FREDERICK P. CLARK ASSOCIATES, INC.
Planning/Development/Environment/Transportation
Rye, New York and Fairfield, Connecticut

August 1, 2008

Subject: **Supplemental Information – Traffic Access and Site Plan Review –
Leroy-West Senior Residence, 77 Leroy Avenue, Darien, Connecticut**

INTERSECTION SIGHT DISTANCE
 Frederick P. Clark Associates, Inc.

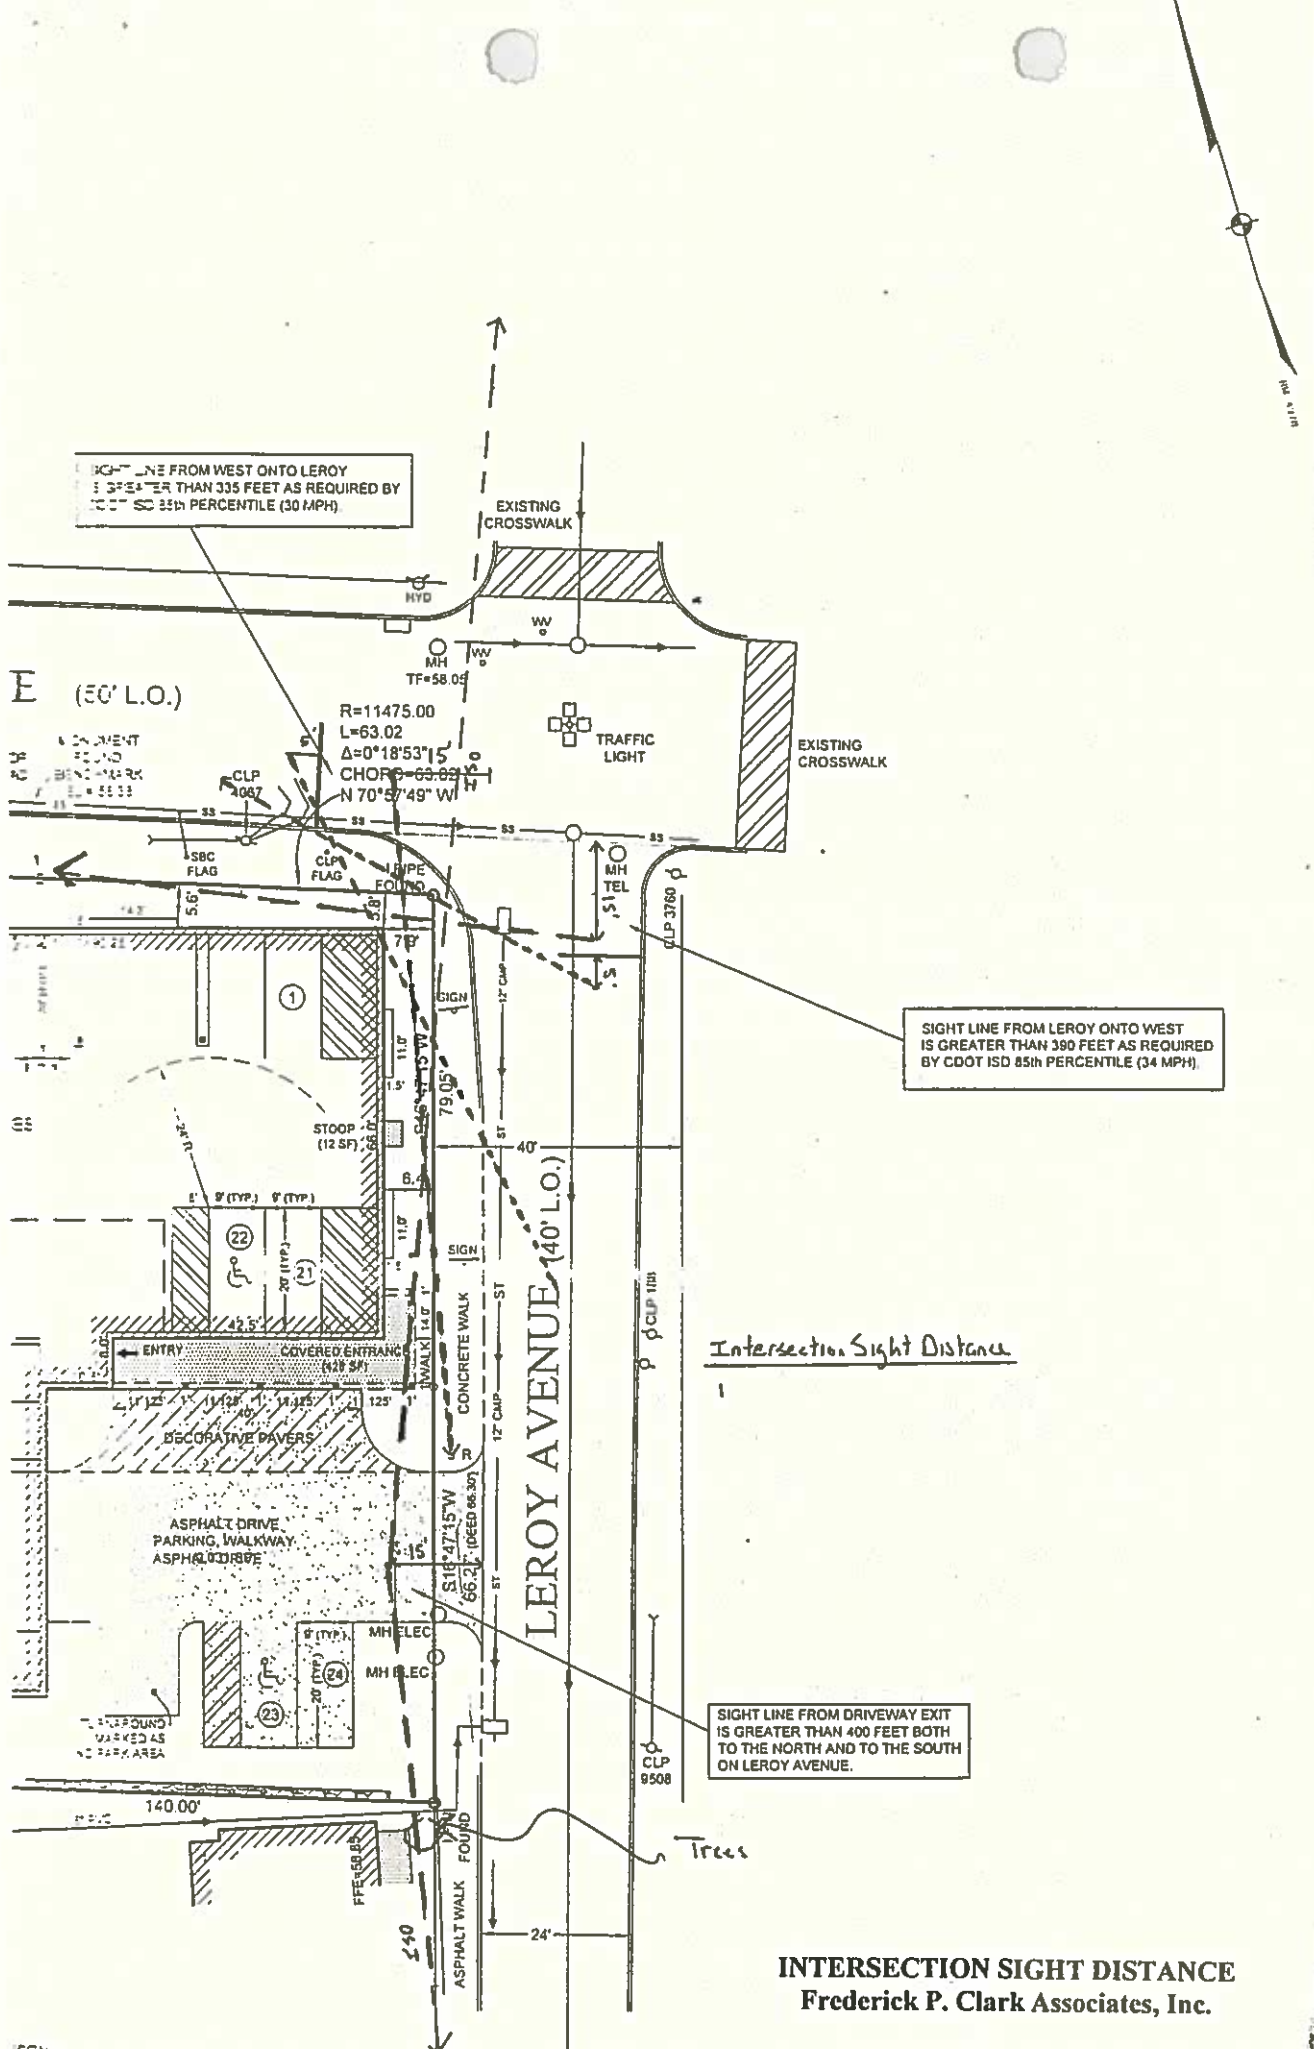
The Applicant "notes" on the Site Plan that the available sight line from the driveway is greater than 400 feet in both directions on Leroy Avenue. However, this is only provided in a note format as the actual analysis was not provided on the Site Plan, as previously requested.

The attached overlay of the Site Plan shows the ISD analysis provided by our office for the proposed access drive. The ISD should be measured 15 feet back from the curb line on Leroy Avenue. The analysis indicates that looking to the north from this proposed driveway, the sight line will cross under the covered building entrance and through at least one of the columns supporting this covered entrance.

Looking to the south from the proposed access drive, the sight line passes through the adjacent property and immediately in front of an existing porch through an existing cluster of trees. These trees are in the sight line area and create an obstruction.

The Applicant should have provided this detailed analysis on a Site Plan that shows the actual 400-foot measurement indicated on the Site Plan.

2. *Leroy Avenue/West Avenue Intersection Sight Distance (ISD) Analysis/Clear Sight Triangle* – At this signalized intersection the Applicant noted that there is a greater than 390 feet sight line on the northbound approach of Leroy Avenue at West Avenue. A similar note is provided on the eastbound approach of West Avenue that indicates greater than 335 feet of sight line is provided.

The attached sketch provides different measurements for the Planning and Zoning Commission to consider, which shows the ISD being measured 15 feet back from the extension of the curb line of the intersecting street. This plan also shows the approximate location of the STOP lines and a sight line measurement from 5 feet behind the STOP line, which is the estimated location of the driver in the vehicle waiting at the STOP line.

The analysis of 15-feet back from the continuation of the intersecting road indicates that a motorist arriving and waiting at the northbound approach on Leroy Avenue may have restricted sight distance to the west. Although this intersection sight line does not touch the corner of the proposed building, field observations indicate that the proposed location of this building is very close to the corner of the subject property and intersection and can obstruct intersection sight lines and create a safety concern at this location. Furthermore, any proposed landscaping, fences or other obstructions in front of the building and within the property could have a significant impact on availability of ISD at this location.

Similar conditions exist for the motorist located on the eastbound approach on West Avenue and looking south on Leroy Avenue along the site frontage.

There is significant concern by the Planning and Zoning Commission and our office, with regard to the available ISD at both the proposed access drive to the site and at the southwest corner of the intersection of Leroy Avenue and West Avenue. The analysis provided by Clark Associates shows that there will be sight distance obstructions when exiting the subject driveway.
